Date: October-12-18
To: Bidders for Norfolk County Bid No. RFP-PW-E-18-73
Engineering Services, Watermains, Sewers and Road Upgrades, Port
Dover
From: Dadean Assam, Project Manager, Public Works Division
Dadean.Assam@norfolkcounty.ca
Subject: Addendum No. 1 (3 page(s) plus 1 page of attachment)

ADDENDUM No. 1

Attachments: Don Jon Blvd. Municipal Drain Plan & Profile

DONJON BOULEVARD MUNICIPAL DRAIN 2008
NORFOLK COUNTY

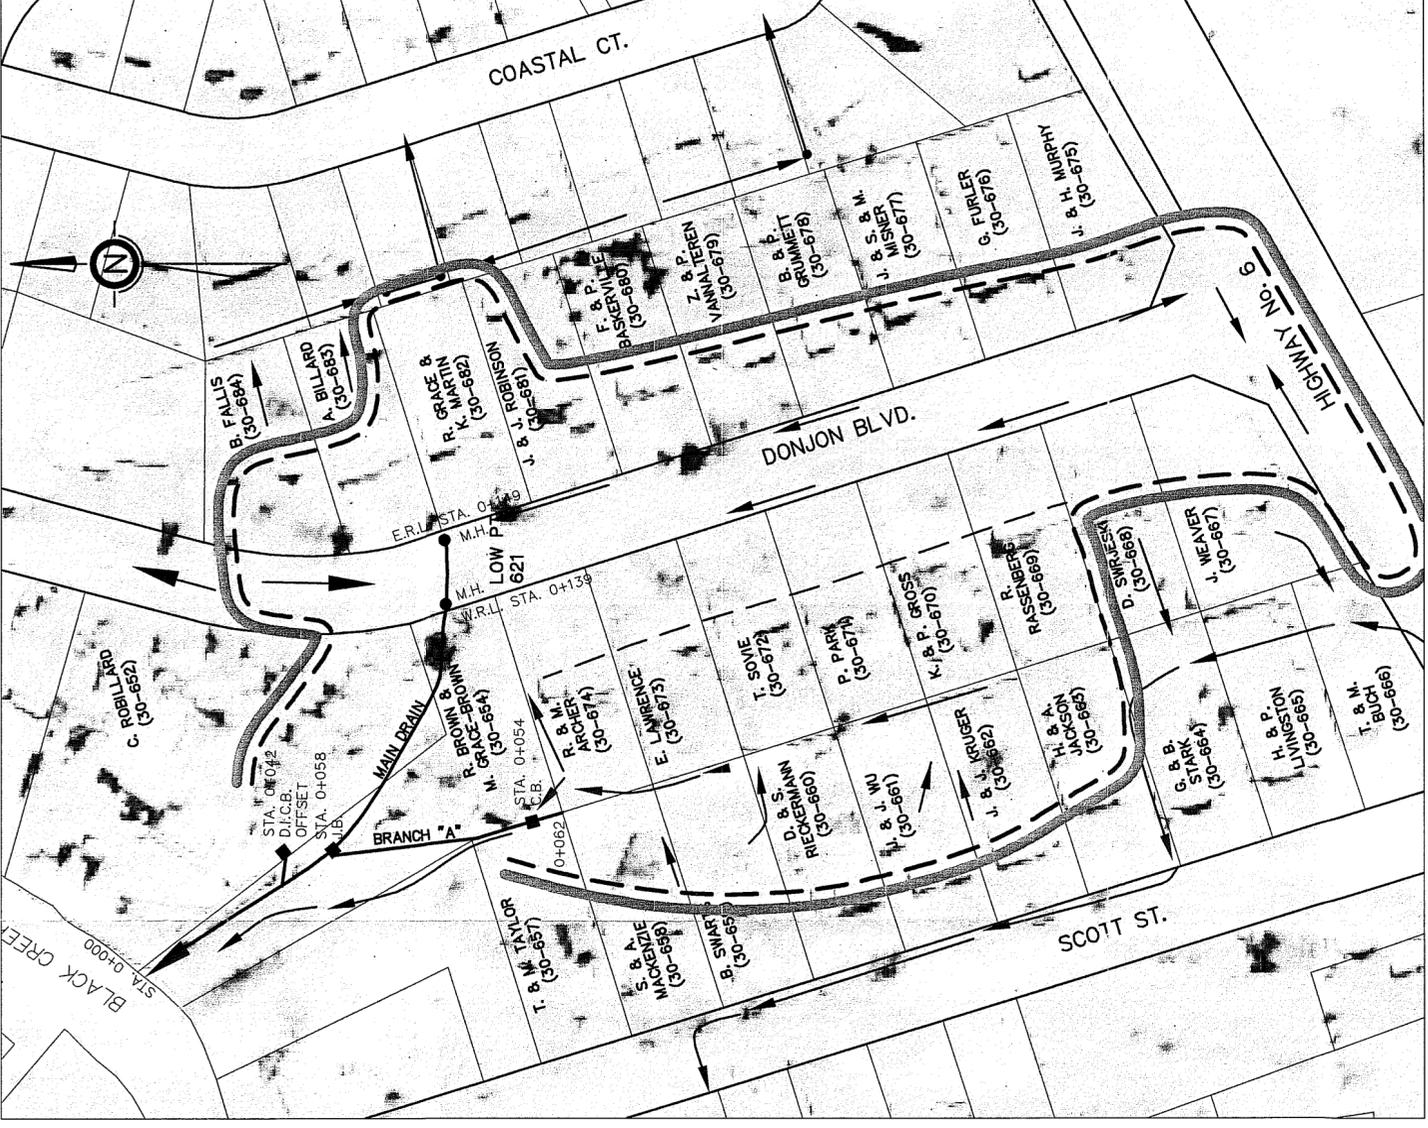
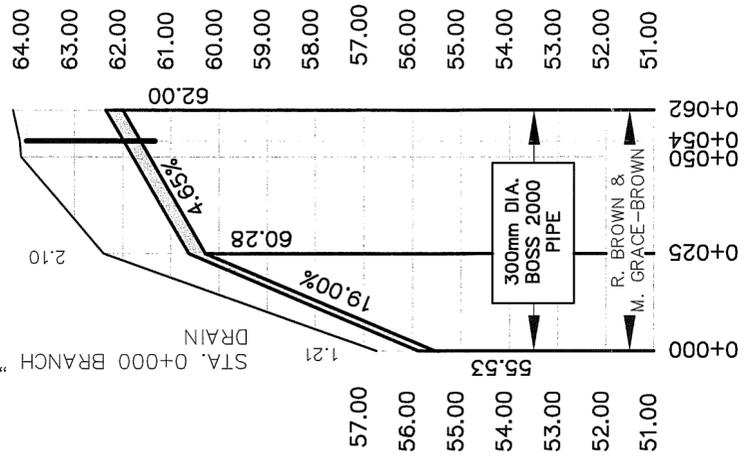
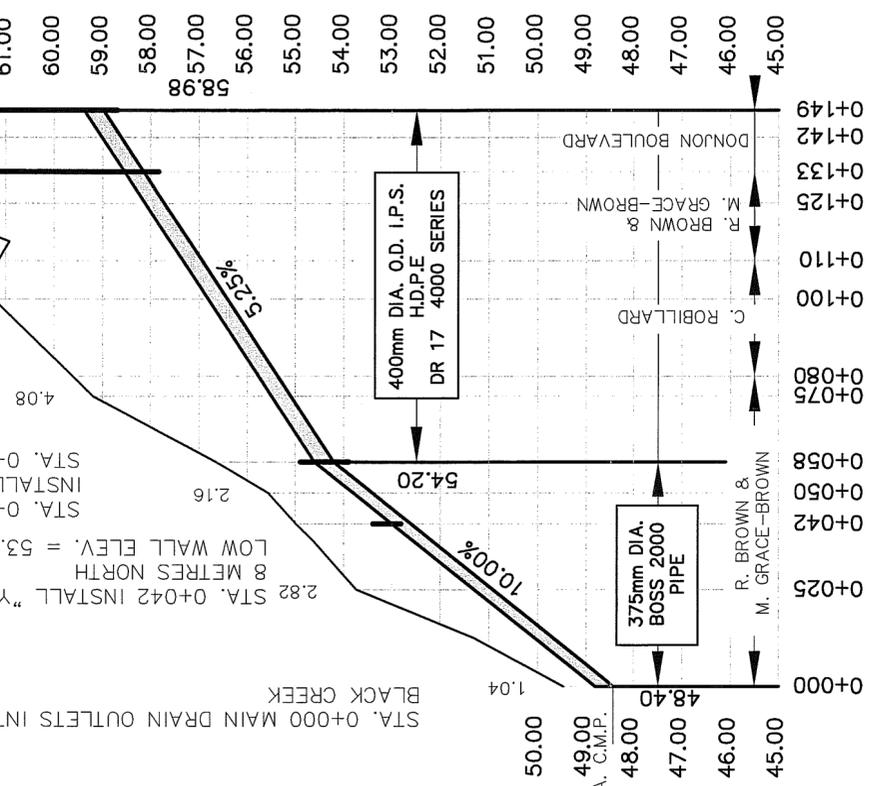
Is the Don John Drain to serve as the outlet for the complete project area or are there other outlets available?

The Don Jon Boulevard Municipal Drain Map attached to this addendum shows an outlet for part of Don Jon Boulevard from Highway 6. Bidders will be responsible to determine capacity of the Don Jon Boulevard Municipal Drain and the legality and adequacies of any other storm water outlet(s) required for other part of the road.
